**Preliminary Drainage Report
Meadow Lake Industrial Phase 1
El Paso County, Colorado**

April 2024

PCD File No. SP236

SHEET DR 2

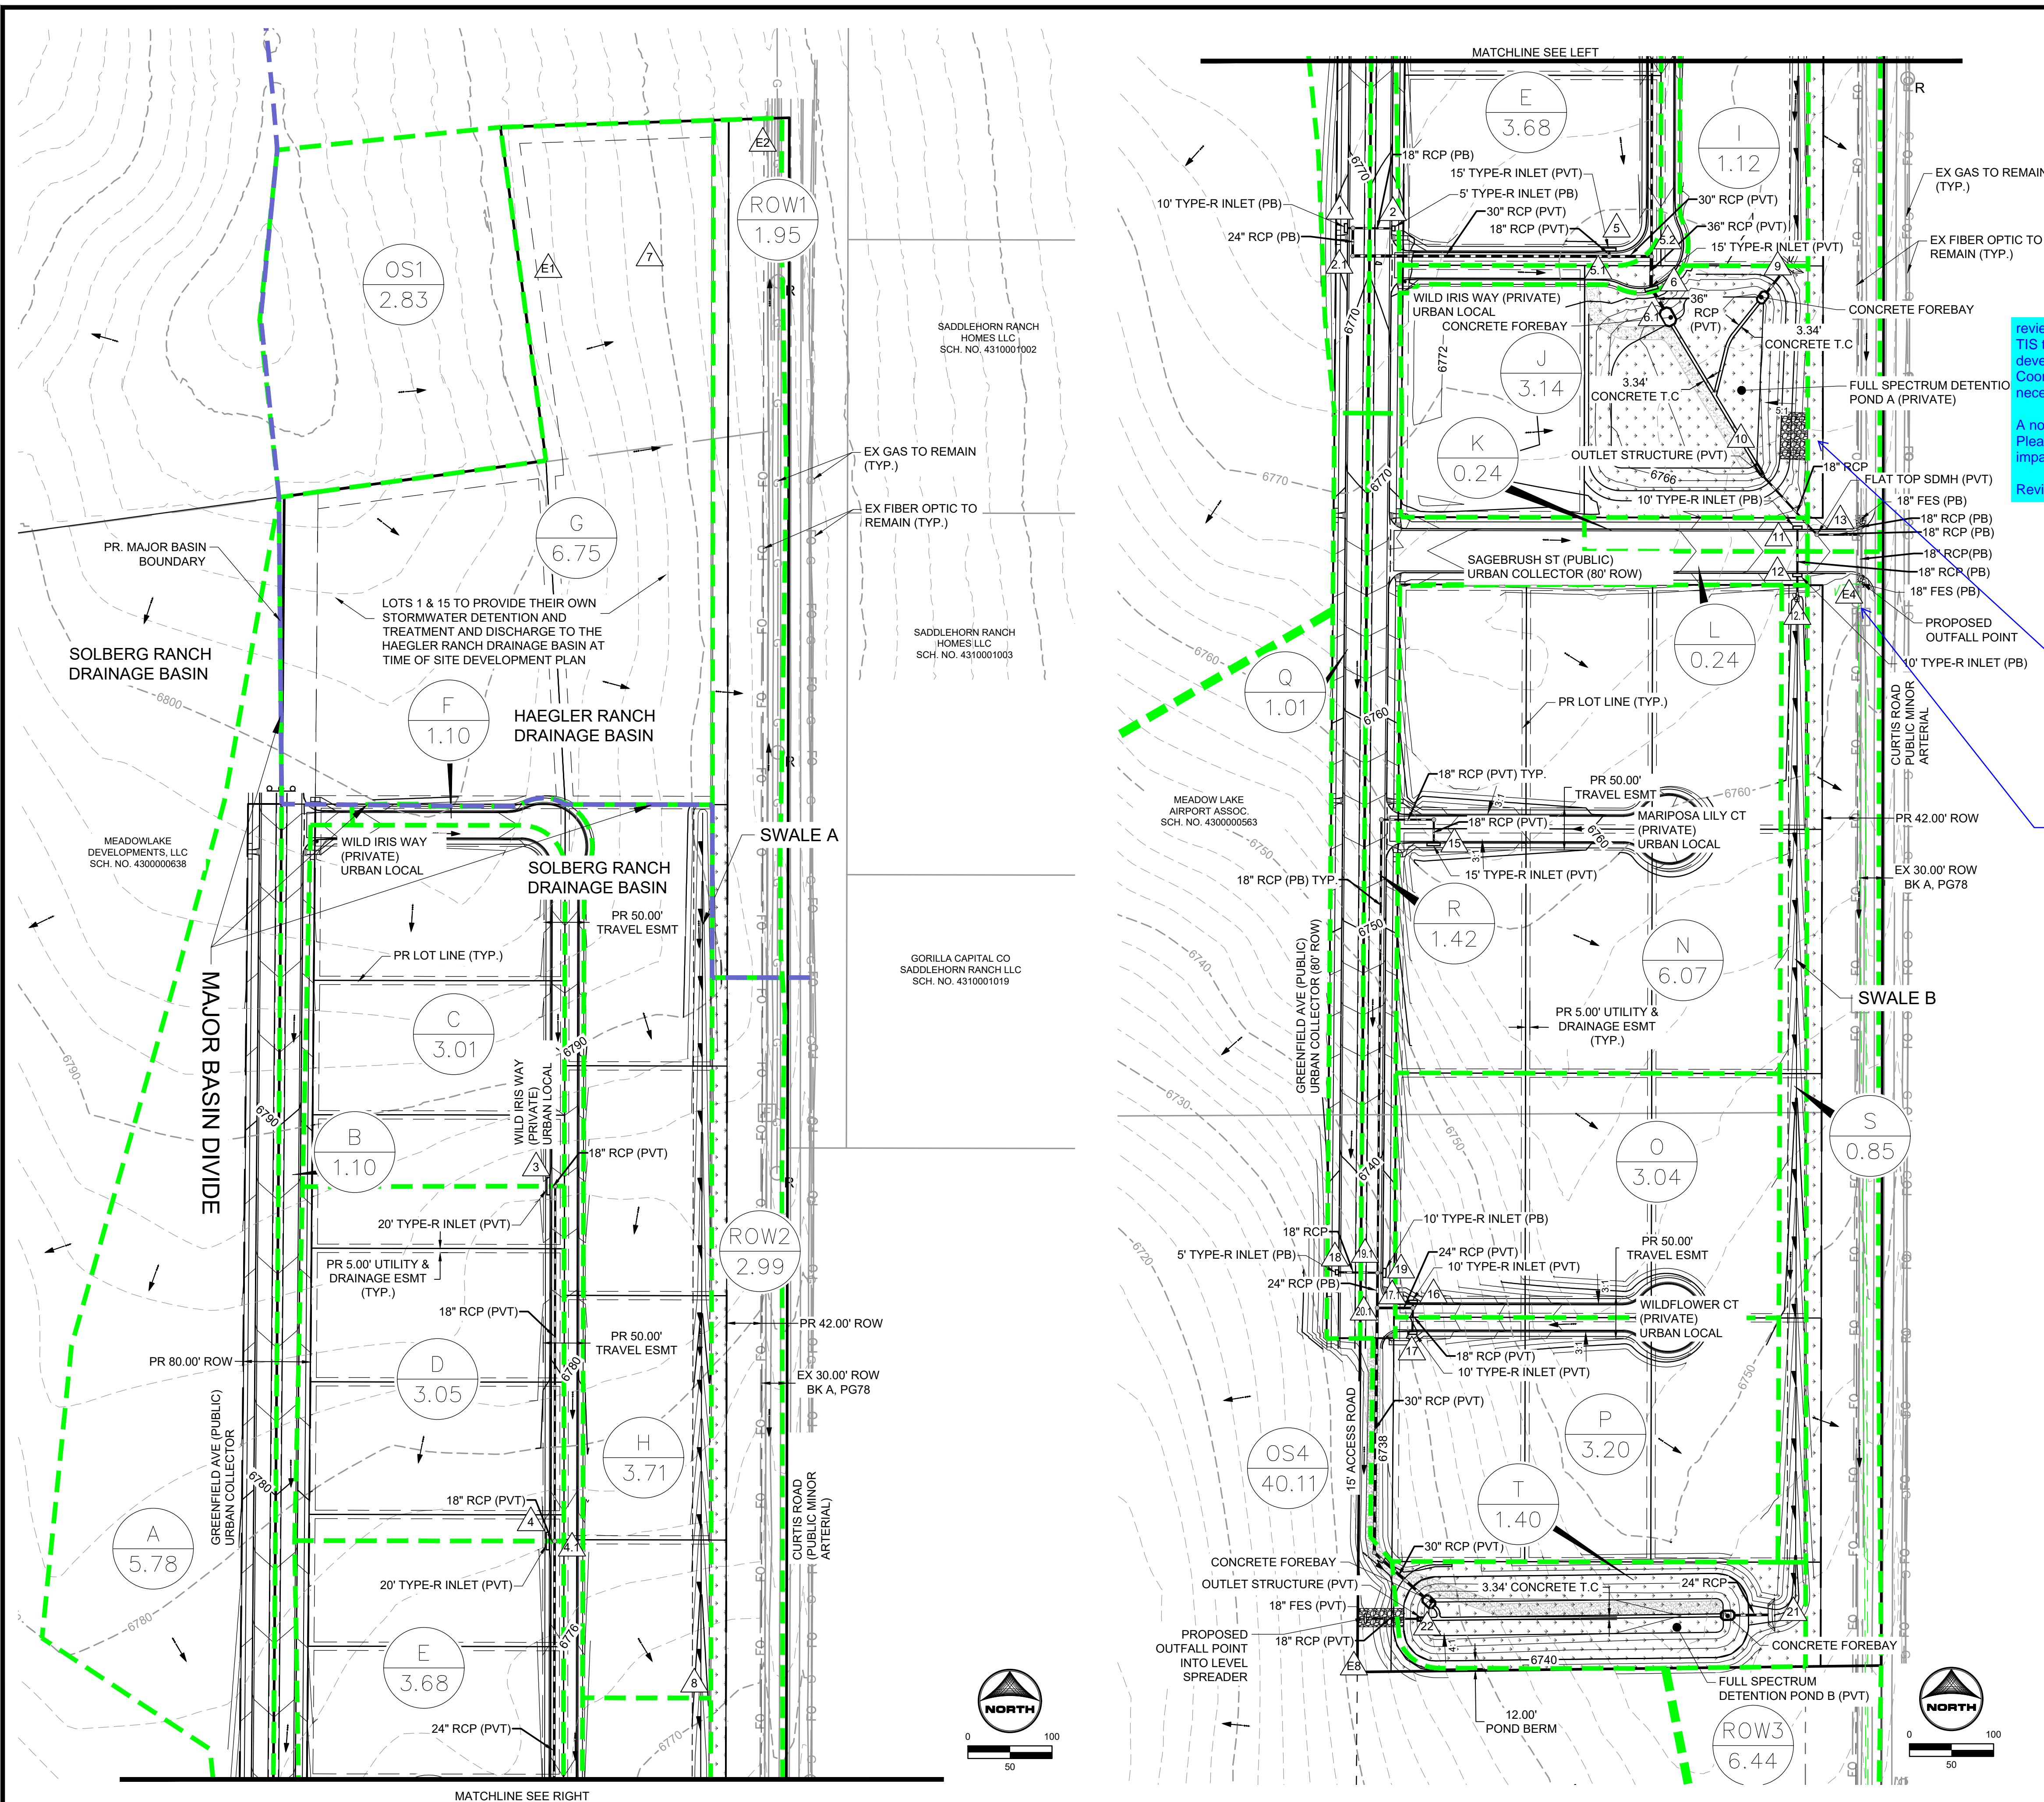
review 1 comment: comments have been provided on the TIS to identify improvements that may be needed with this development to Curtis Rd roadway cross section. Coordinate with the traffic engineer and account for any necessary improvements in your design.

Review 2: unresolved. Please address the above comment.
